# Weyerhaeuser – Longview

## Best Available Retrofit Technology (BART)

### Response to 2-7-08 Ecology Comment Letter

Figure 2- Diagram of No. 10 Recovery Boiler showing combustion air ports & boiler tubes

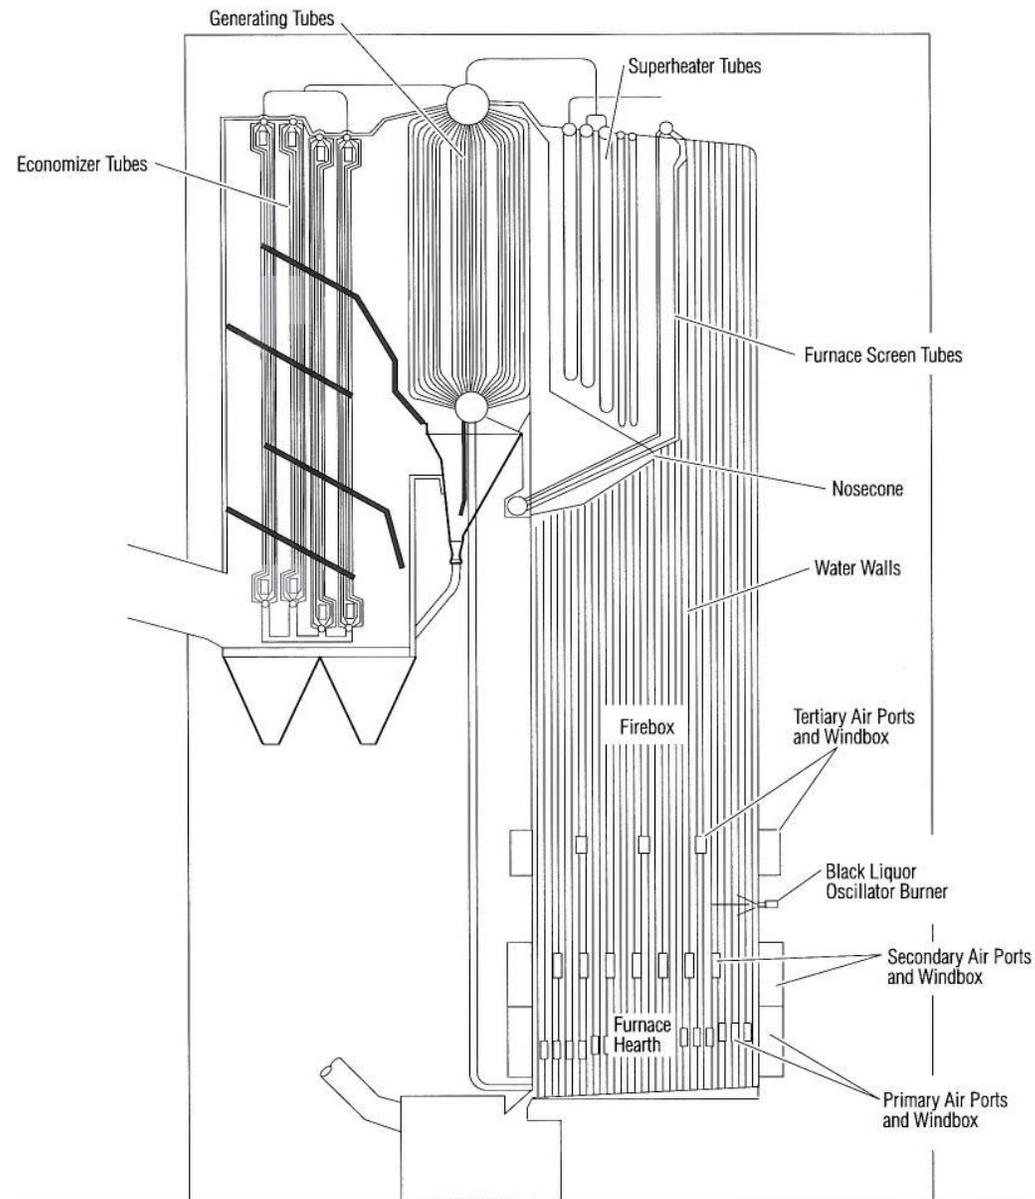
4. No. 10 Recovery furnace, NOx control evaluation, page 8. In Step 1, you note that the staged combustion is already practiced in the recovery boiler. What level of staged combustion is currently utilized in the furnace – secondary, tertiary, or quaternary staging? Are there opportunities to ‘fine tune’ the staged combustion to further reduce the NOx production? Please discuss the possibility of further NOx reductions through improvements to the existing staged combustion system.

*As shown in Figure 2 (below), No. 10 Recovery Furnace delivers primary, secondary and tertiary combustion air into the boiler firebox. Tertiary air was added in 1995 when the lower section of the Recovery Furnace was replaced. Primary and secondary air systems include air pre-heating, while tertiary air is at ambient temperature. Primary, secondary and tertiary air ports are located roughly 17, 28 and 63 feet above ground level, respectively. This air inlet distribution generates a reducing zone between the primary and secondary air ports, a liquor drying zone between the secondary and tertiary air ports, and an oxidizing zone in the upper firebox between the tertiary air ports and the boiler screen tubes.*

*Adding a fourth stage would again require placing a new section in the Recovery Furnace. There is not likely enough room within the furnace between the tertiary air port and the start of the boiler tubes to add a fourth stage of combustion; hence, the furnace would have to be rebuilt and the upper section raised. This would likely require rebuilding the entire boiler and boiler building.*

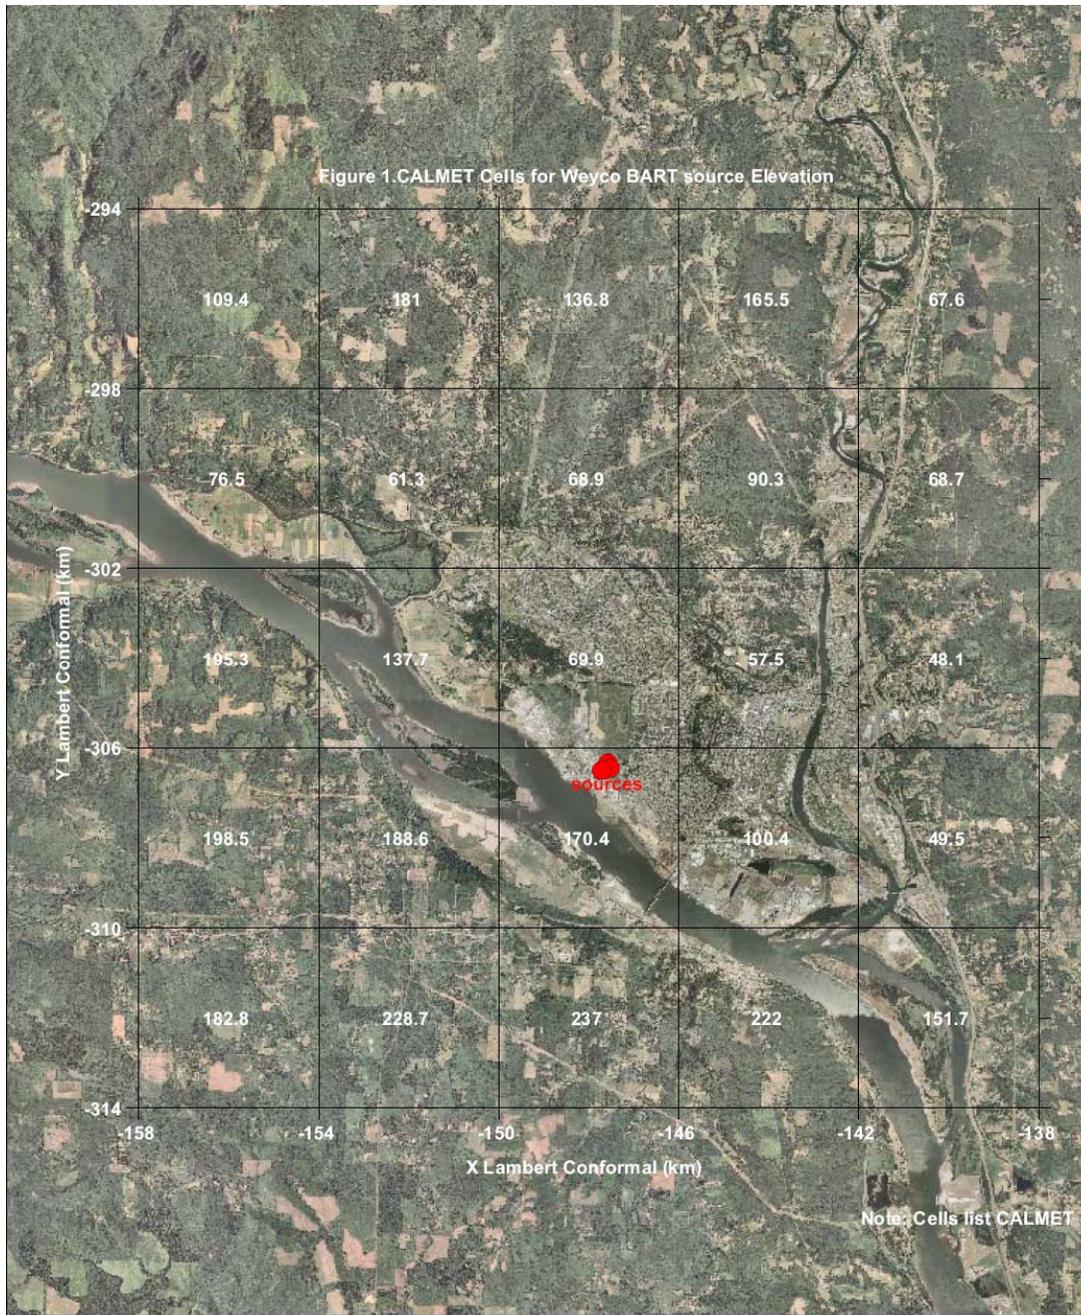
Was the over fire air and staged combustion analysis submitted as part of a BACT analysis for the recent boiler capacity upgrade? Is so, what parts of the Notice of Construction package discuss this analysis and the effects of implementing it? If the analysis was not part of the Notice of Construction package, please supply a copy of the analysis showing the pre change condition and expected improvements resulting from the changes made.

*The purpose of the new OFA system was to improve the system's ability to deliver overfire air into the combustion zone of the boiler. The old system delivered overfire air through a large number of relatively small air ports in the sidewalls at two elevations in the boiler. These ports were ineffective at delivering air to mix with the uncombusted fuel rising up the center of the firebox, because the many small air ports did not provide the momentum necessary to penetrate into the center of the combustion zone. Overfire air tended to channel up the sides of boiler, without providing the desired oxygen distribution or air to fuel mixing. As a result, almost all*

*The new system, designed and installed by Jansen, utilizes fewer, larger air ports equipped with jet nozzles capable of forcing overfire across the width of the boiler, providing effective mixing and delivering air to where it is needed in the core of the firebox.*

<i>Pre-Project Baseline OFA Flow:</i>	<i>44 KPPH</i>
<i>Post-Project OFA Flow:</i>	<i>140 KPPH</i>
